SUBJECT: Inter County Connector (MR 06809-SHA-1)

Subject: Intercounty Connector Mandatory Referral  
Aesthetic Design Treatment

SUBJECT: Staff Comments for ICC Mandatory Referral July 13, 2006

### **Signage and Toll Gantries**

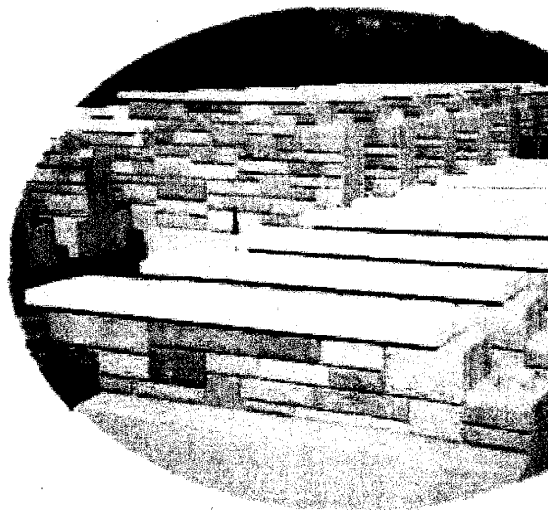
- Place overhead signage and toll gantries to the side of the roadway. The proposed overhead structures are not compatible with the desired parkway character and will be seen from the adjacent neighborhoods. This is a significant concern of the residents. Parkway character is diminished by the proposed overhead structures. See page 26 and 27 for an illustration of proposed structures.
- Paint the backs of signs NPS Brown.
- Consider decorative sign treatments on major intersecting highways. See attached photograph.

### **ICC Maintenance Facility (WEST)**

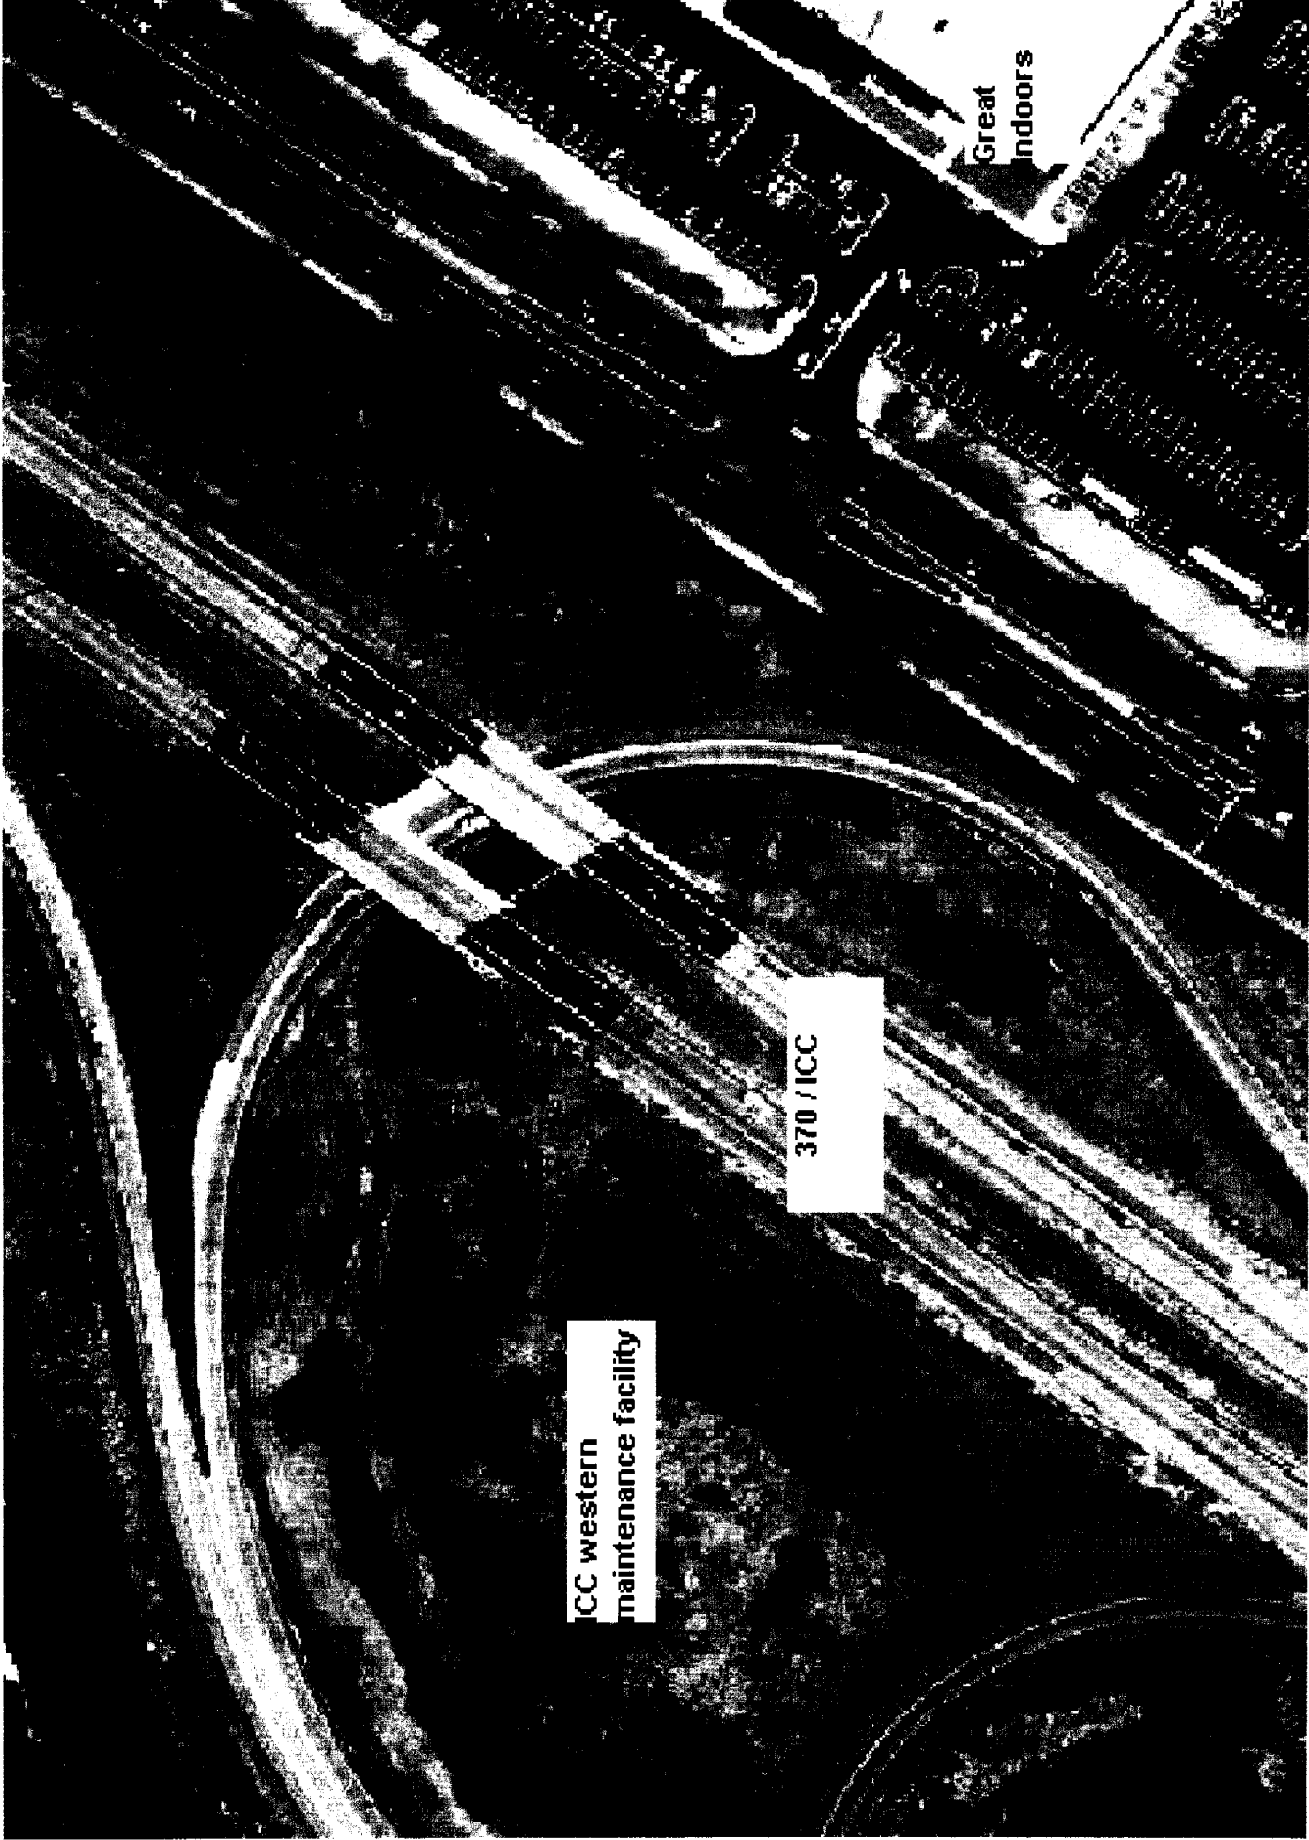
We, see problems with Casey Property location for the ICC Maintenance Facility (WEST) this facility would be next door to the Giant food plaza and residential neighborhoods. The new trucks would be utilizing the same streets as the citizens of Derwood. Truck traffic is an issue on Shady Grove road presently, with this location the trucks would come out of Crabbs branch, right on to Shady Grove, then right onto 355 and then on to 370 heading West. Why do we need the state run trucks mixed in with the neighborhood traffic?

- Enclosed above an idea for a new location for the ICC Maintenance Facility (WEST). The facility would be on the same elevation as 370, so it would be a simple access for the state for their seasonal use.

The proposed land would not need to be purchased because it would be within the "state-parkway" site area versus the Casey property that was proposed?

(Note: The location is near the junctions with 355 and across 370 Great Indoors areas. *See map attached*).
